OAKLANDS FARM SOLAR PARK

The Applicant's Response to the Third Written Questions

Document Ref: EN010122/D6/14.3

Image 1: Extract taken from the Illustrative Landscape Strategy Plan

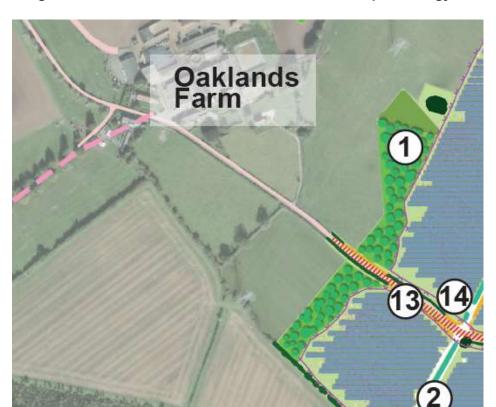
<u>ExQ</u>	ExQ3 issued on Tuesday 12 November 2024. Responses are required no later than Deadline 6, which is on Tuesday 26 November 2024.		
	Please could the Applicant justify the claimed reduction in		
	magnitude of change in views and update the ES as necessary?

The RVAA states that the hedgerow between fields O1 and O2 will be enhanced further to assist in filtering views of PV panels on the rising landform within field O1. Although this mitigation measure will play an important part in integrating the development into the landscape and filtering views of the PV panels, the main reason for a reduction in the magnitude of change upon Pennywort Cottage (as stated in the RVAA) is the proposed belt of

woodland understorey planting with trees, which will be planted around the western edge of the PV panels within fields O2 and O5 (i.e. in-front of the panels when viewed from the eastern façade and rear garden of Pennywort Cottage). The location of this planting is marked as number 1 in the image below (Image 1) which is an extract taken from the Illustrative Landscape Strategy Plan (Figure 1a of Appendix 5.6 – Outline Landscape and Ecological Management Plan).

The planting will be well established and closer to semi-maturity by Year 10, filtering views of the proposed development. Therefore, the adverse visual effects experienced from Pennywort Cottage will gradually reduce over time by the mitigation measures, and as judged in the RVAA, will reduce the magnitude of visual change to **low-medium** at Year 10.
